STAFF QUERIES, SET 2  
(RESPONSES TO ANDREA KOCH E-MAIL)

FOR THE  
**Mariposa Energy Project**  
(09-AFC-03)

# Mariposa Energy Project

## Staff Queries, Set 2

**Contra Costa County Airport Land Use  
Compatibility Plan Traffic Pattern Exhibits**

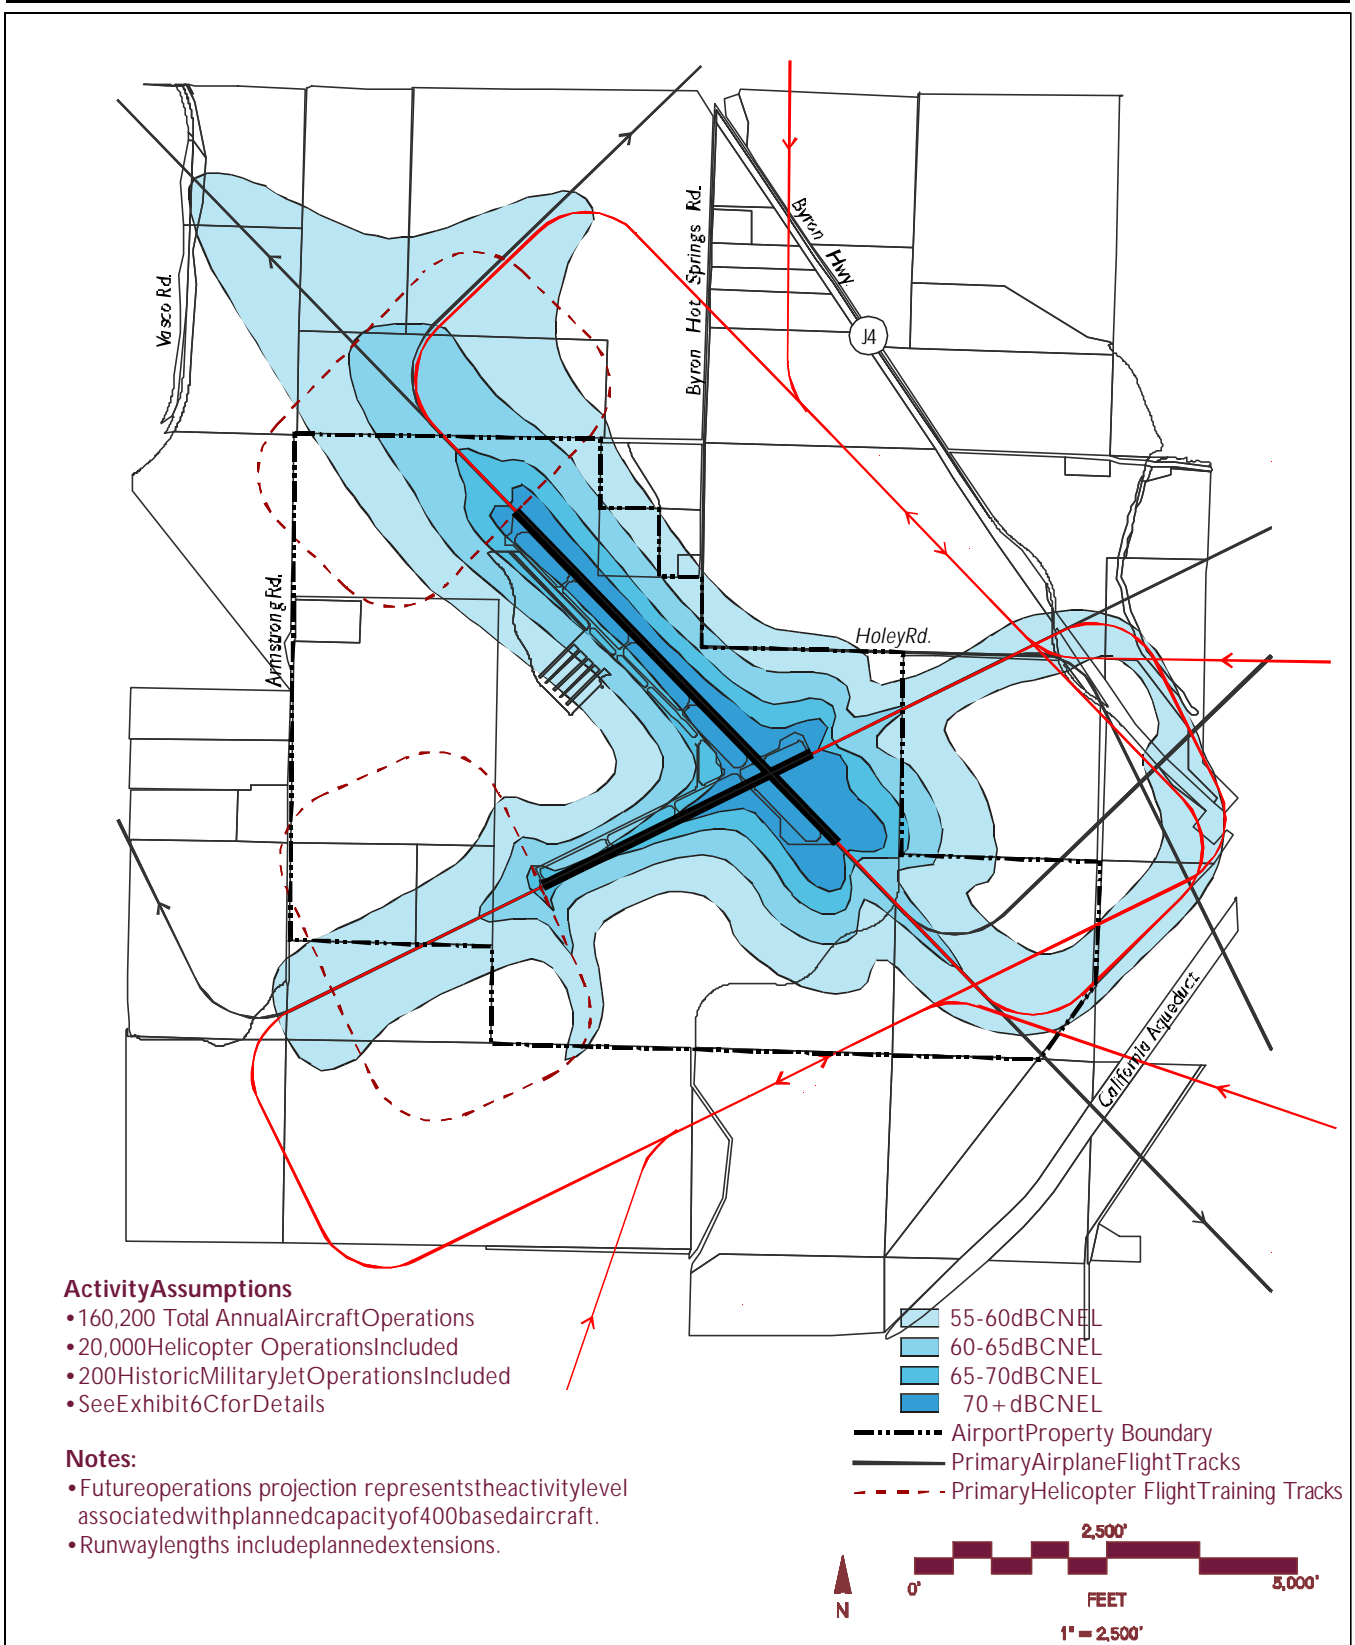
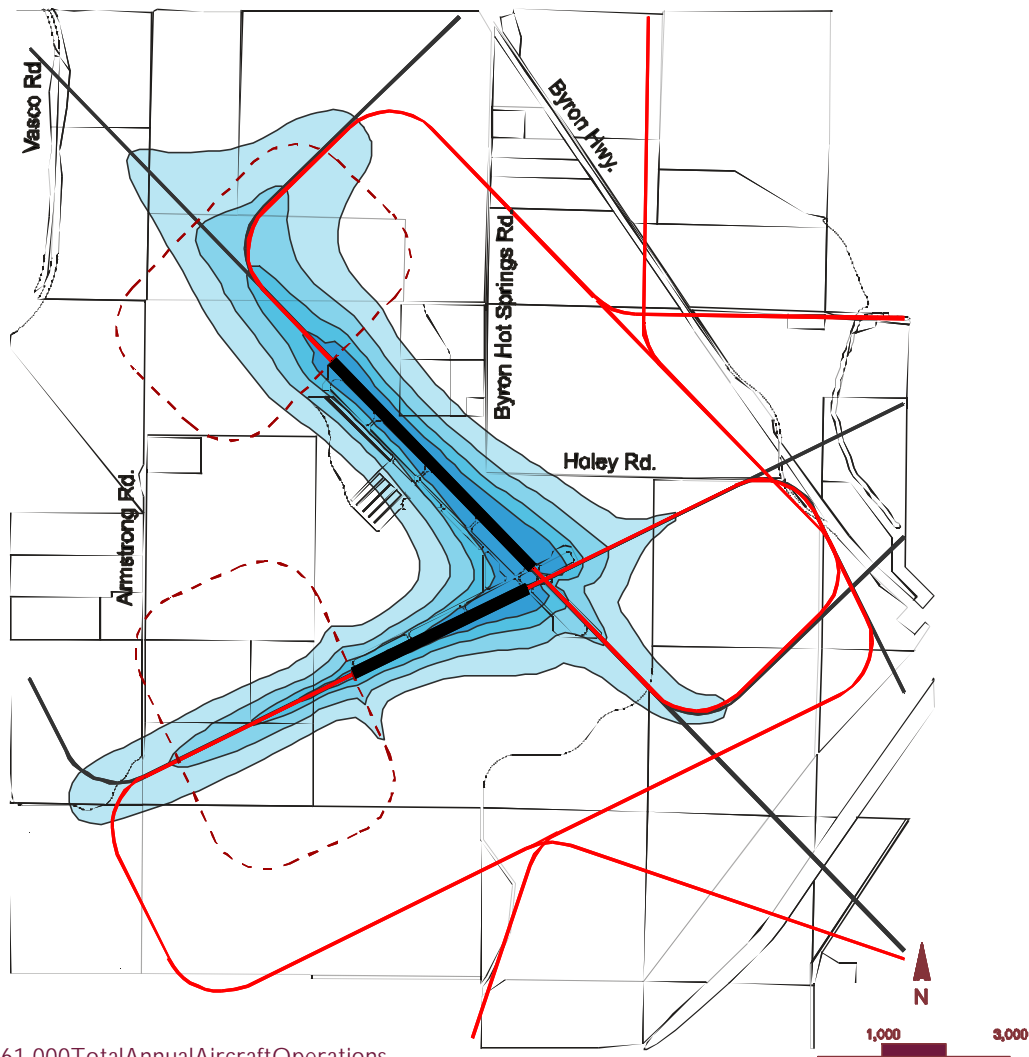
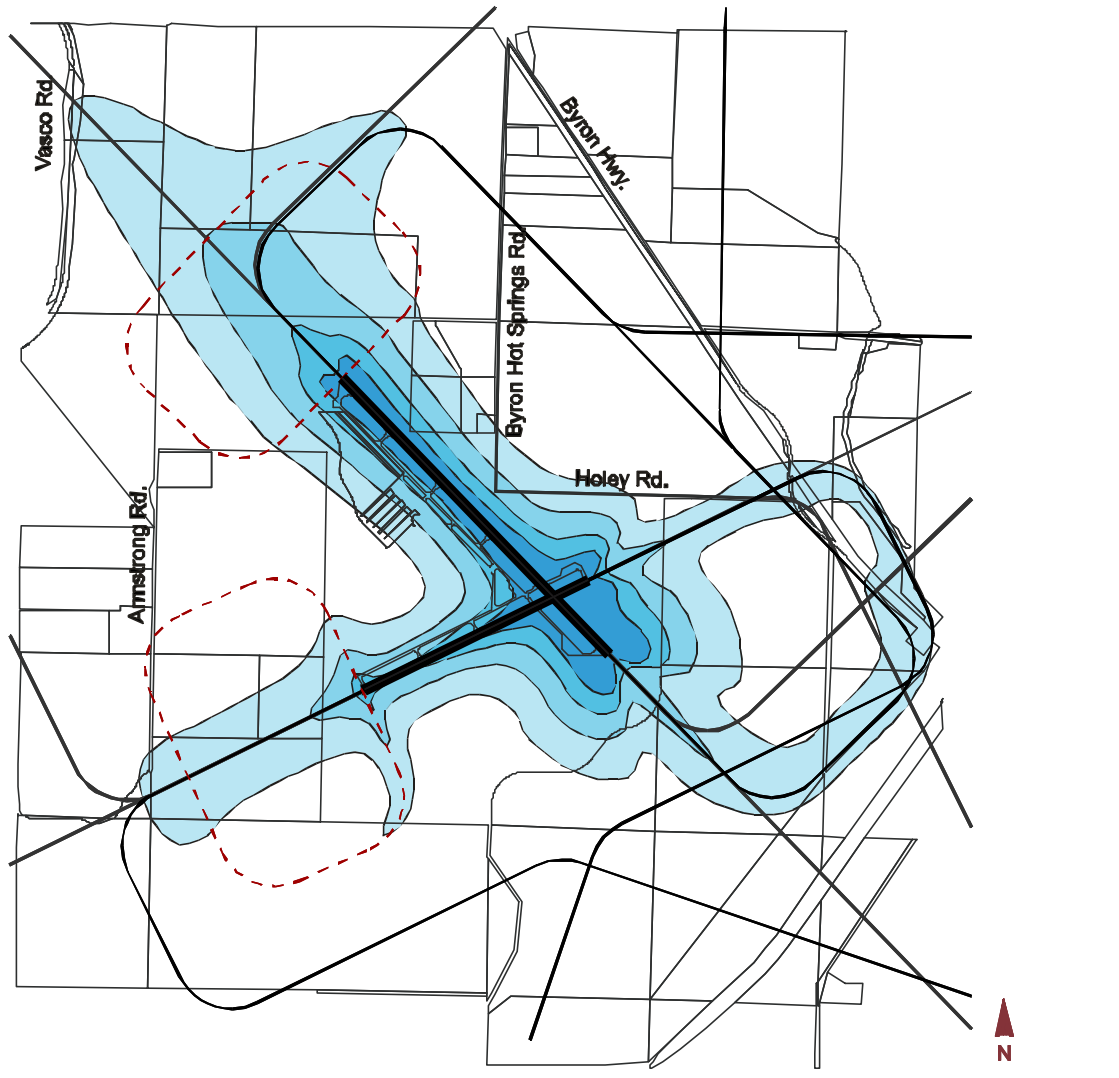
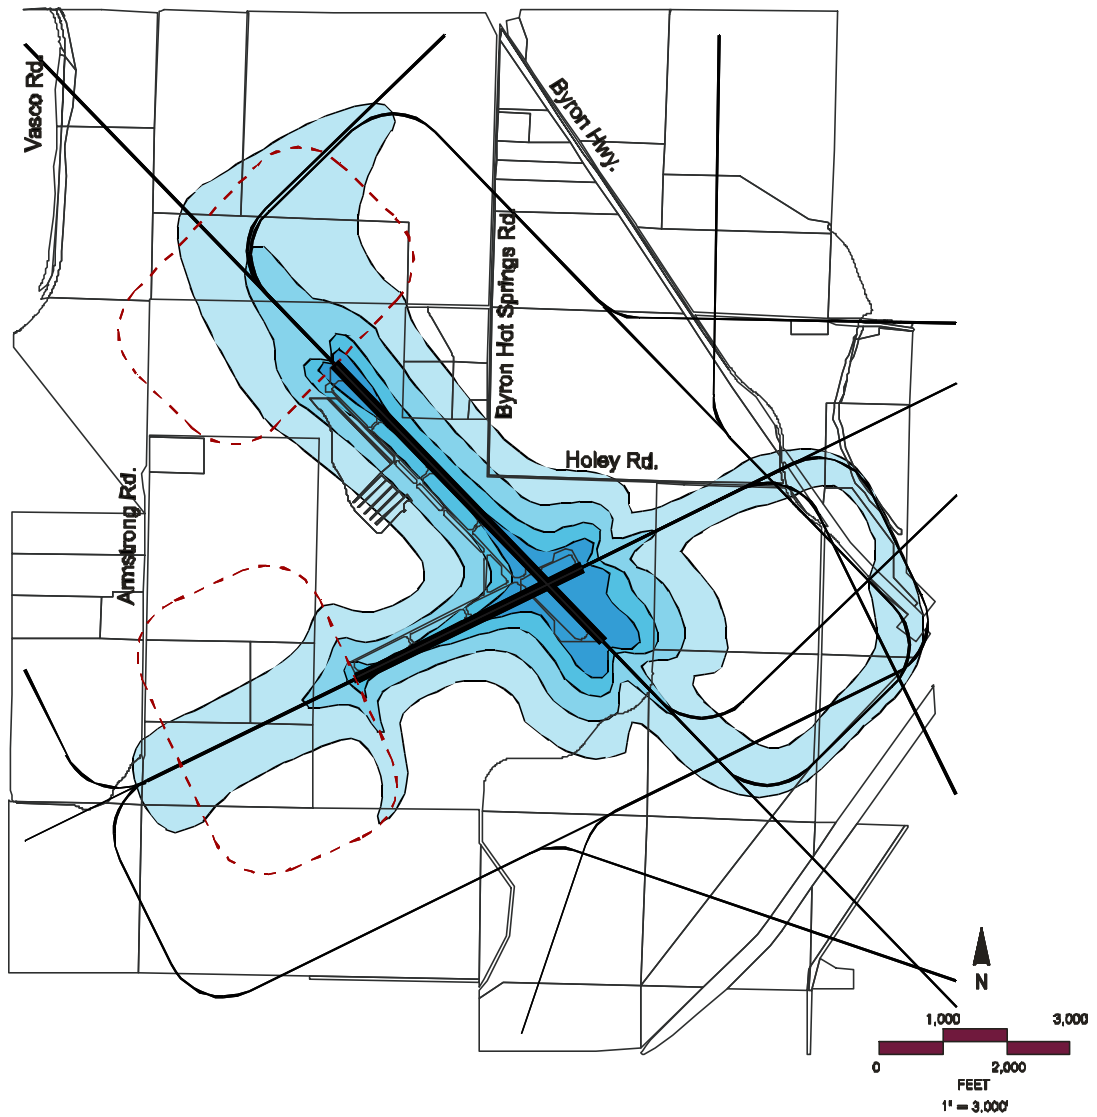
SQ23. Are there any graphics showing air traffic patterns at the Byron Airport?

Attachment SQ23-1 includes maps from the Contra Costa County Airport Land Use Compatibility Plan: Figure 4C and Exhibits 6D, 6E & 6F. Attachment SQ23-2 presents the AirNav description of runway patterns in the Runway Information portion of the AirNav FAA information. Detailed discussion of the approach patterns can be found in Staff Query Set 1, responses to SQ-2 and SQ-3. Attached also is Attachment SQ23-3, which indicates the typical Visual Flight Rule ("VFR") traffic patterns around Runways 23 & 5 and 30 & 12 based upon FAA Order 7400.2 G, "Procedures for Handling Airspace Matters, Figure 6-3-11, since Byron Airport is approved by the FAA for Category A & B aircraft.

# Byron Airport Flight Track Data

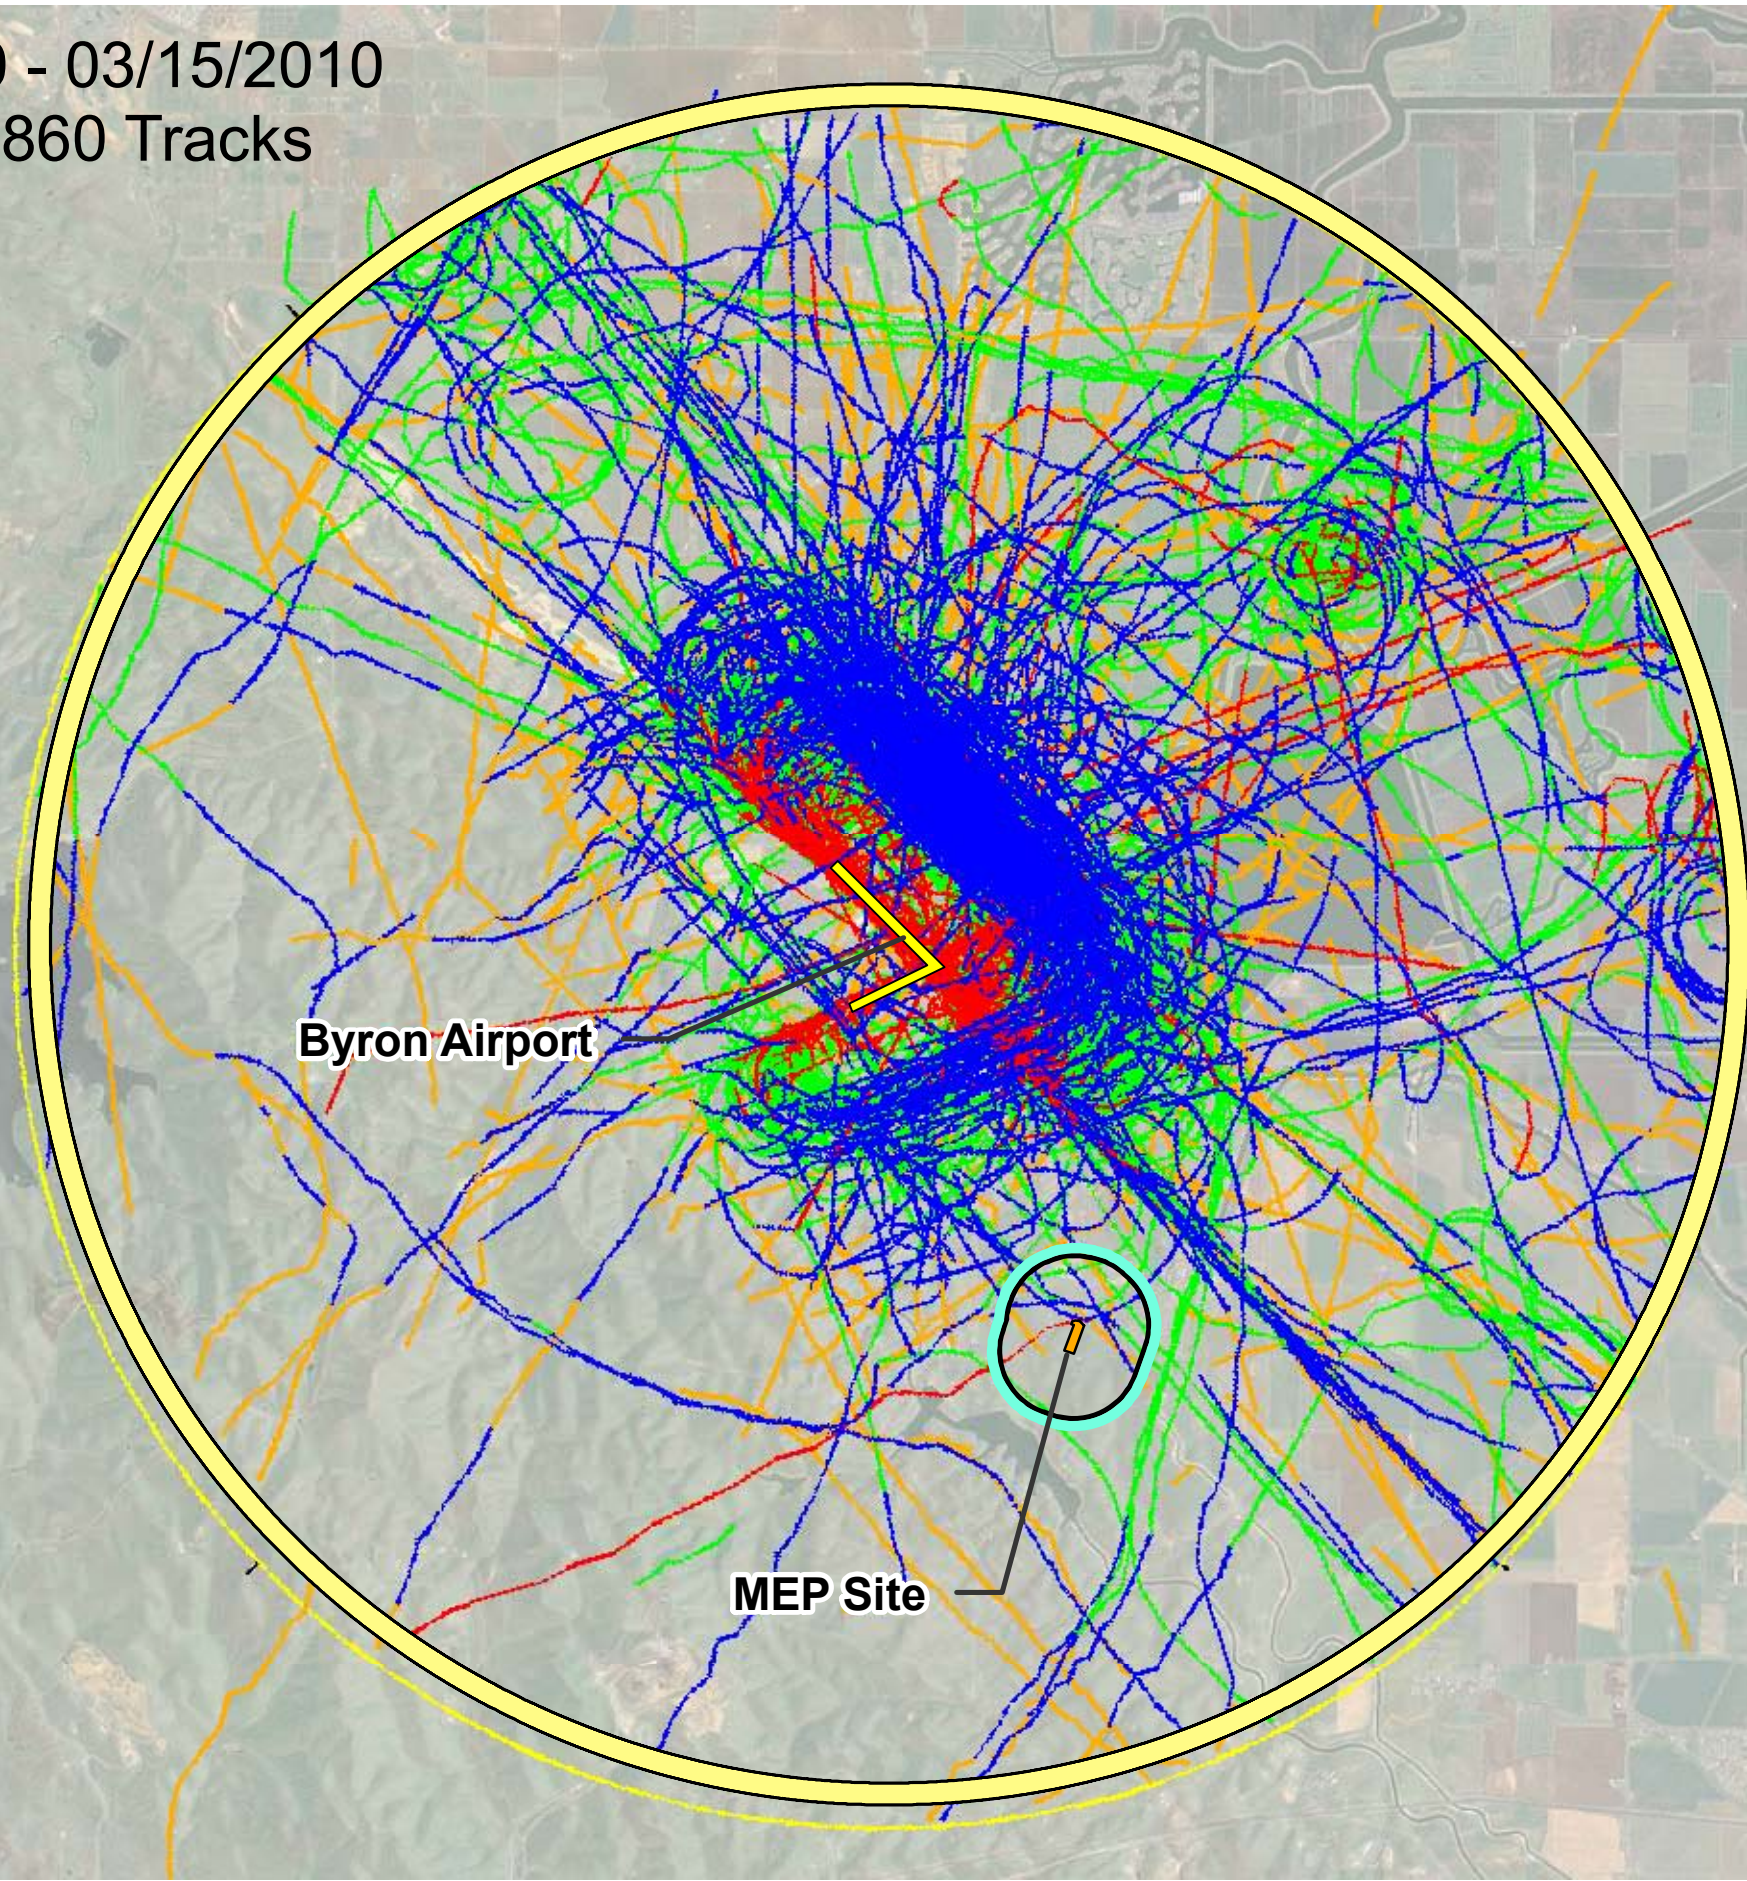
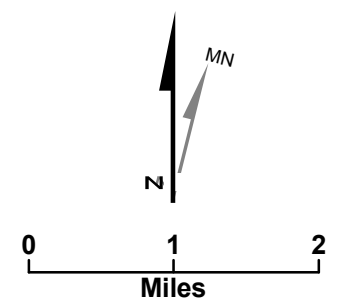
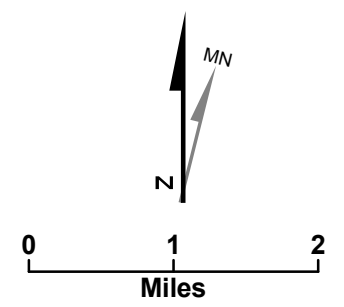
SQ25. Is there any data on the number of over flights that occur at the site of the proposed MEP?

the FAA in the initial data request and future requests were for continuous fifteen (15) day periods. The combined flight tracks for each period are presented in Attachment SQ25-1.

During the first period there were 209 flight tracks recorded on the radar and most of these were either in expected approaches or flight patterns. Those that were not in expected approaches or patterns tended to be north of the Byron Airport or east near the Clifton Court Forebay. Of the 209 flight tracks only 13 were within 0.5 miles of the proposed Mariposa Energy location, of these 3 were between 500 - 1000 feet AGL (referenced to the Byron Airport elevation), 6 were between 1000 - 1300 feet AGL and 4 were 1300 - 1500 feet AGL. *None were below 500 feet.* Even without the Mariposa Energy facility being located there very few aircraft overfly this area, if the facility was there, aircraft would easily see it and avoid overflight.

For the second period there were 860 flight tracks recorded within 5 miles of the Byron Airport and again most of these are in expected approaches or flight patterns for Byron Airport or located to the northeast of the airport. Of the 860 recorded flight tracks only 14 were within 0.5 miles of the proposed Mariposa Energy site and *only one* was indicated between 0 - 500 feet AGL (0.12%). Four were located between 500 - 1000 feet AGL, 5 were identified as being between 1000 - 1300 feet AGL and 4 were between 1300 - 1500 feet AGL.

The radar flight track data indicates that most aircraft generally follow the air traffic patterns around the two runways at Byron Airport. The few planes that would fly over the proposed site of the Mariposa Energy facility, upon seeing it, could easily maneuver not to overfly the facility, especially if information about Mariposa Energy is posted on the Byron Airport Air Nav site and in the Airport/Facility Directory. Total flight counts would be expected to be higher during summer months; however the geographic usage patterns should be consistent, with the vast majority of aircraft adhering to recommended flight patterns near Byron Airport.
